**IN THE ENVIRONMENT COURT
AT CHRISTCHURCH
I TE KŌTI TAIAO O AOTEAROA
KI ŌTAUTAHU**

Decision No. [2023] NZEnvC 244

CORRIGENDUM OF THE ENVIRONMENT COURT

PROPOSED MITIGATION PLAN
LOT 2 DP 523873

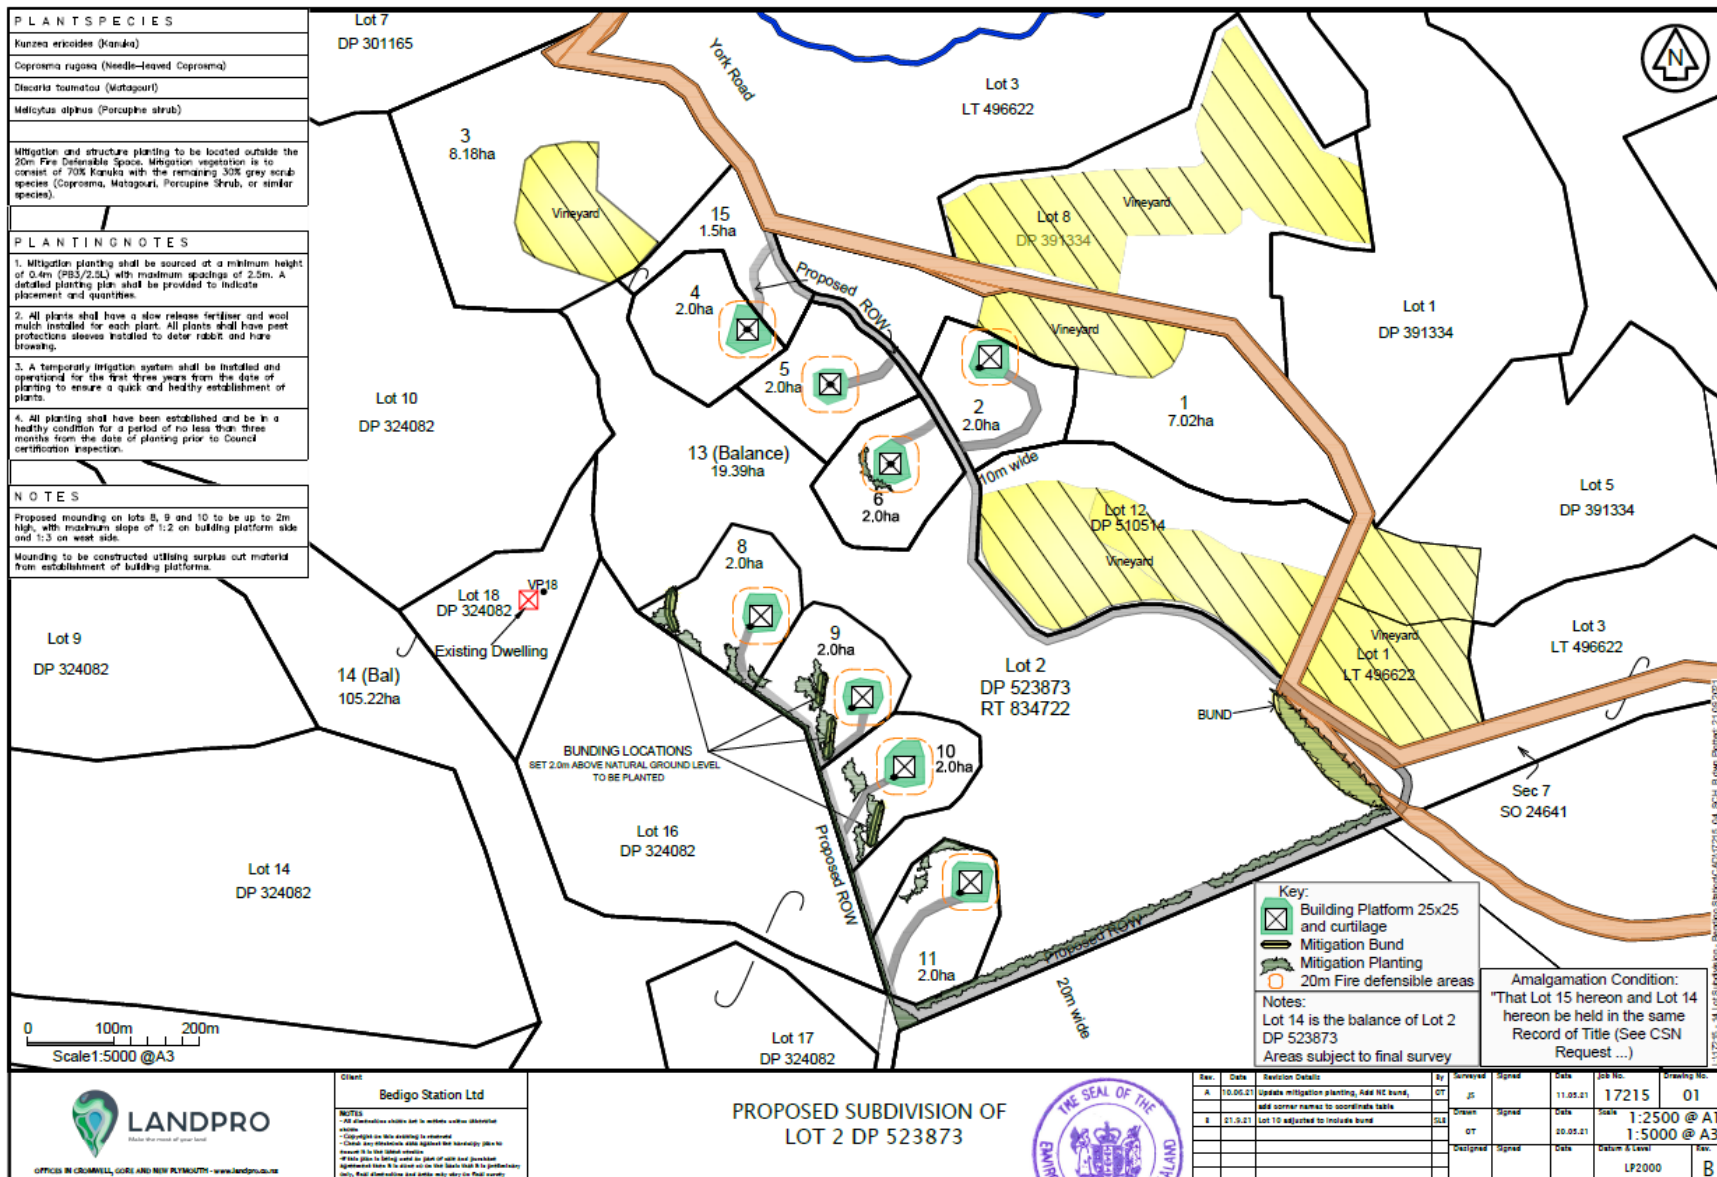
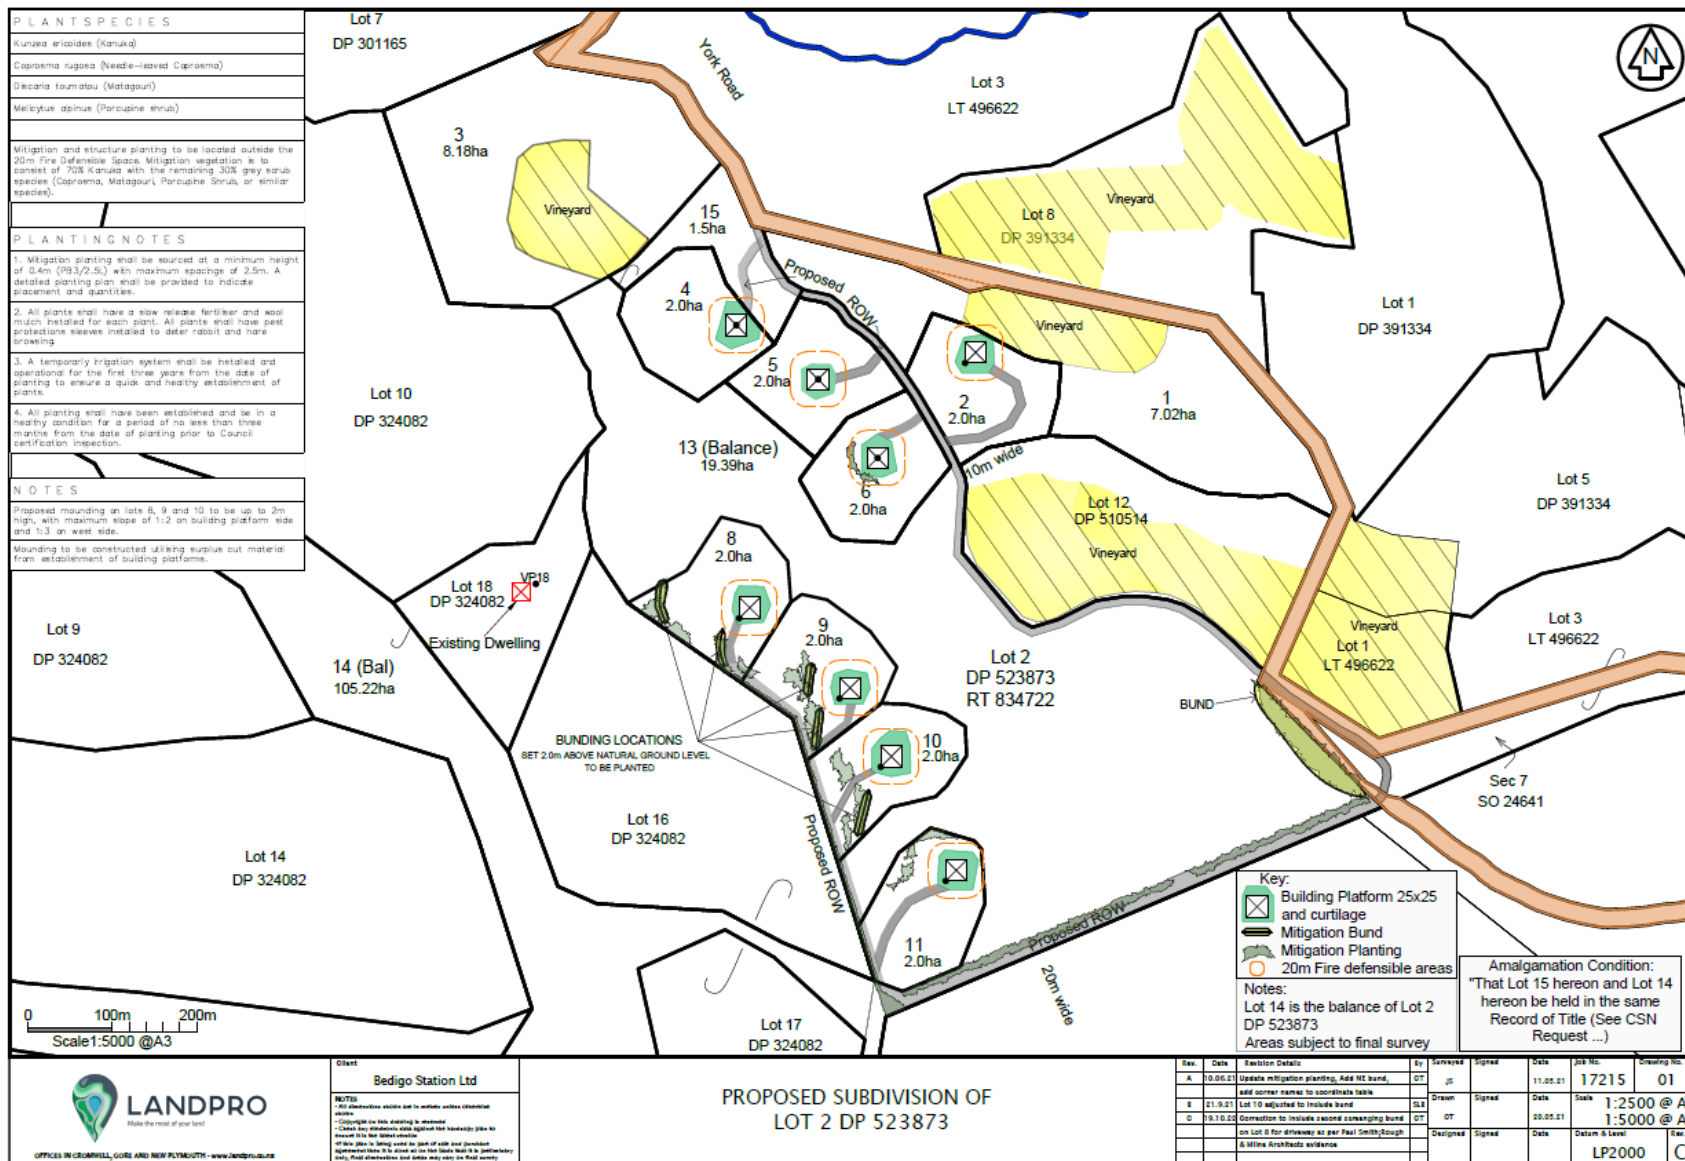
[11] The corrections required involve replacing the approved plans with replacement plans that identify the second mound on Lot 8. Consequential

[13] The plans as confirmed by the final decision are set out in Appendix 1. These are to be replaced with the corrected versions set out in Appendix 2.

[15] Subdivision condition 1 and land use condition 1 are to be amended as set out above at [12] and as set out without tracking in Appendix 3. The plans referred to in those conditions are to be replaced with the replacement plans identifying the second mound on Lot 8 as set out in Appendix 3.

The subdivision shall be undertaken in accordance with the Proposed Subdivision of Lot 2 DP 523873, Drawing 01, Rev ~~BC~~, ~~dated 21.09.21~~ dated 20 May 2021 and Proposed Mitigation Plan Lot 2 DP 523873, ~~Rev B~~, Drawing 03, Rev C, ~~dated 21.9.21~~ dated 20 May 2021.

This land use consent authorises residential building platforms on Lot 2, Lots 4-6 and Lots 8-11 as shown on the Proposed Subdivision of Lot 2 DP 523873 Rev ~~BC~~ Drawing 01 ~~dated 21.09.21~~ and Proposed Mitigation Plan Lot 2 DP 523873 ~~Rev B~~ Drawing 03, Rev C ~~dated 21.09.21~~ dated 20 May 2021.

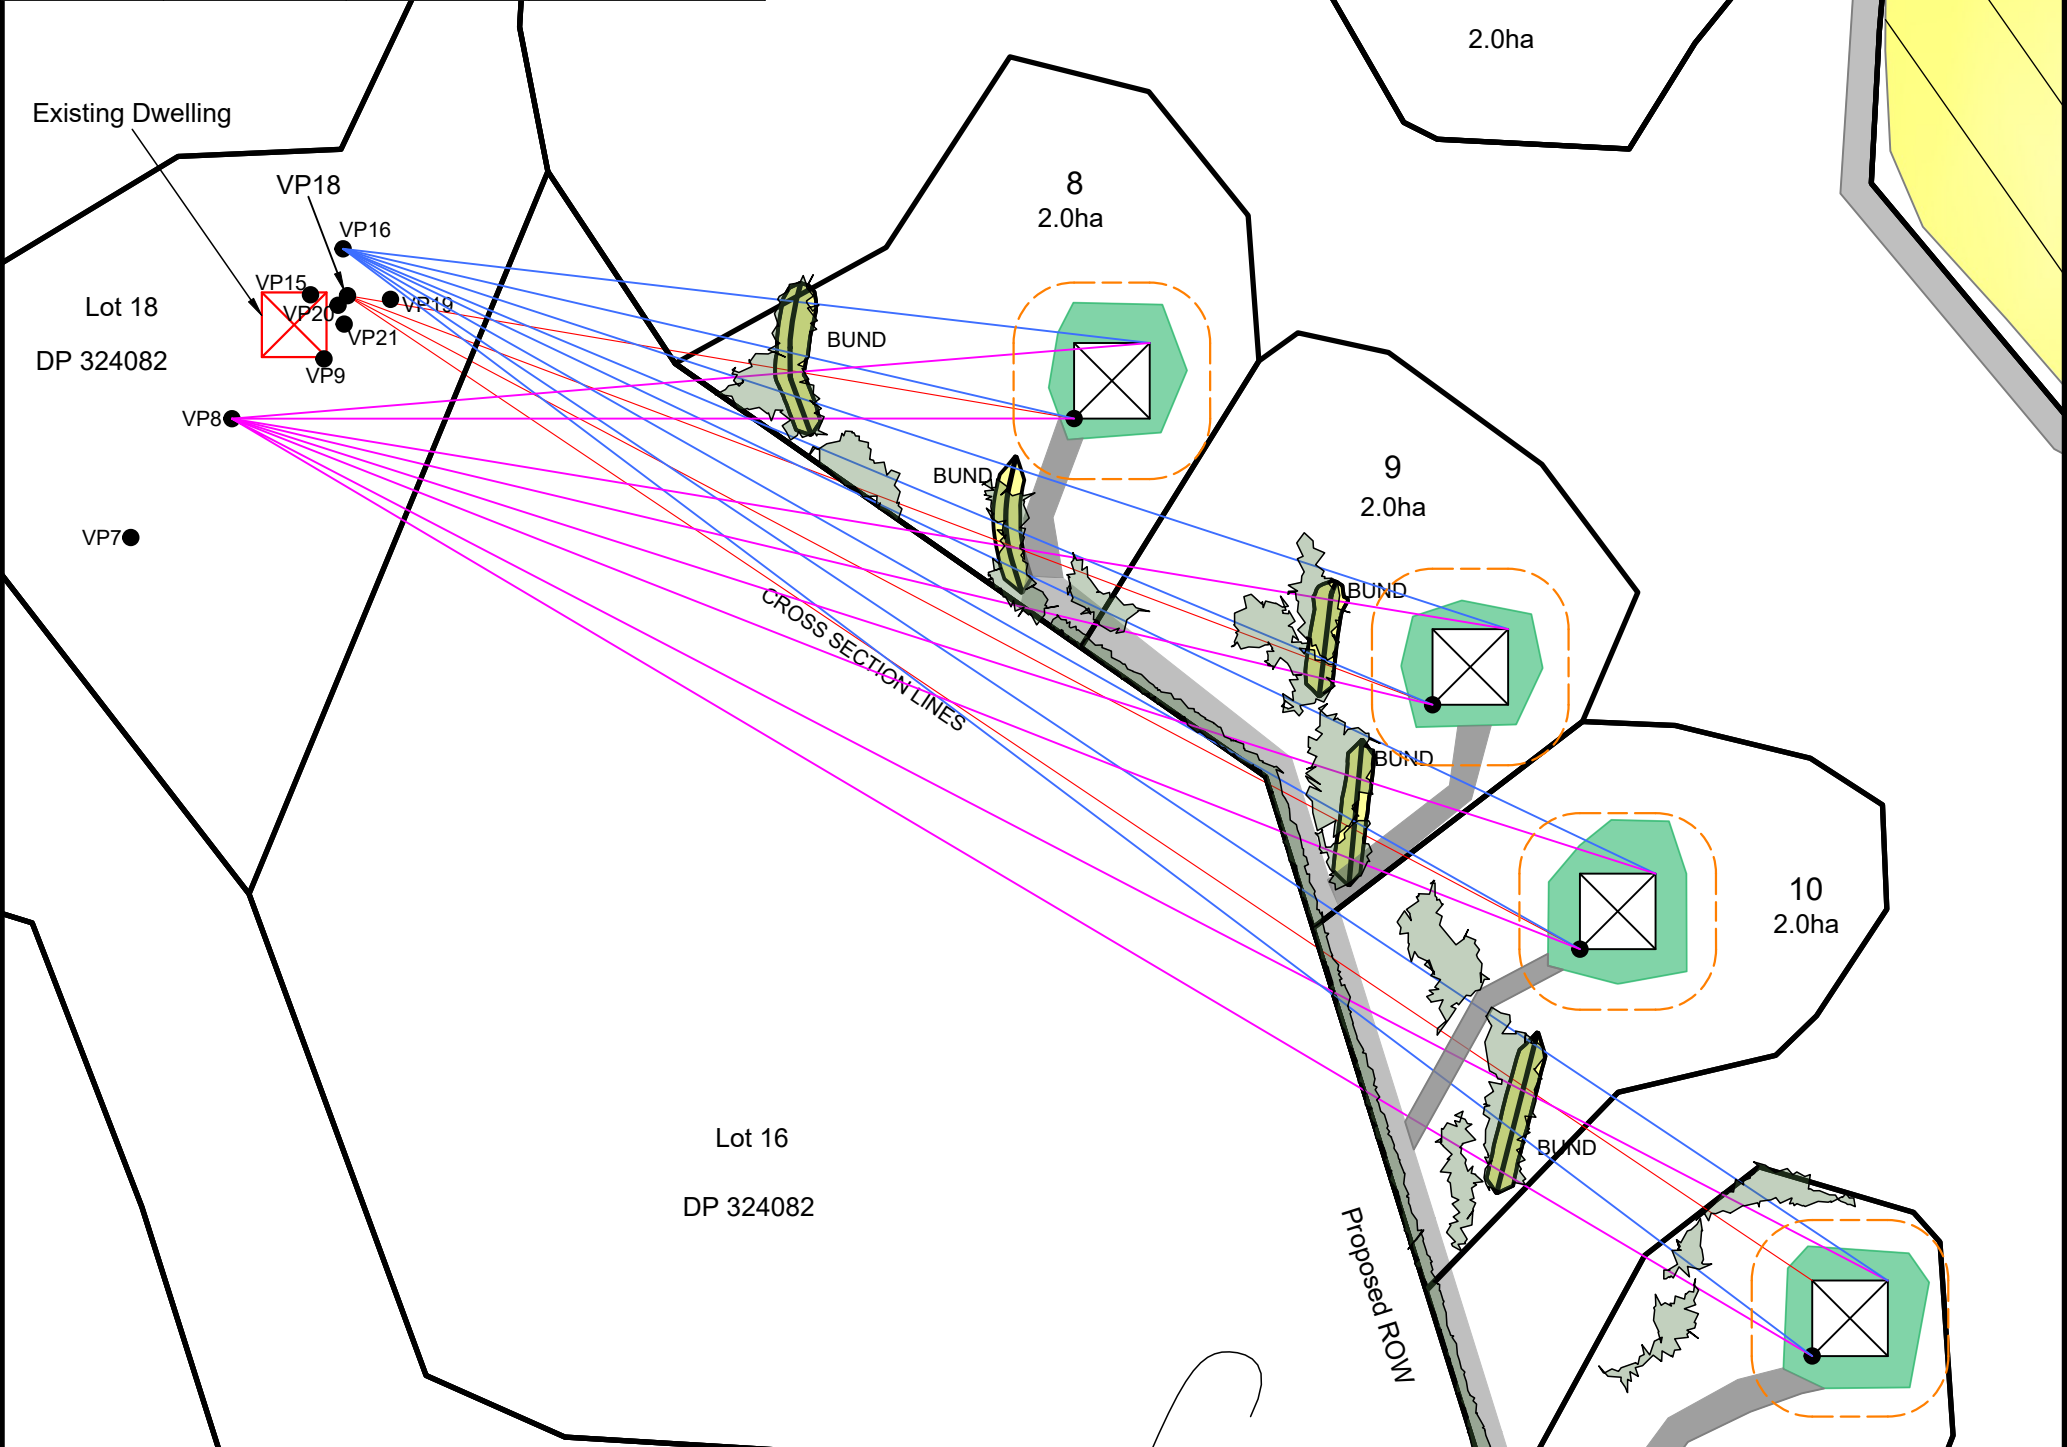
Rev.	Date	Revision Details	By	Surveyed	Signed	Date	Job No.	Drawing No.
A	10.06.21	Update mitigation planting, Add NE bund, add corner names to coordinate table	GT	JS		11.05.21	17215	03
B	21.9.21	Lot 10 adjusted to include bund	SLB	Drawn	Signed	Date	Scale	
C	19.10.22	Correction to include second screening bund on Lot 8 for driveway as per Paul Smith; Rough & Milne Architects evidence	GT	GT		20.05.21	1:2500 @ A3	
				Designed	Signed	Date	Datum & Level	Rev.
							LP2000	C

1. This land use consent authorises residential building platforms on Lot 2, Lots 4-6 and Lots 8-11 as shown on the Proposed Subdivision of Lot 2 DP 523873 Drawing 01, Rev C, dated 20 May 2021 and Proposed Mitigation Plan Lot 2 DP 523873, Drawing 03, Rev C, dated 20 May 2021.
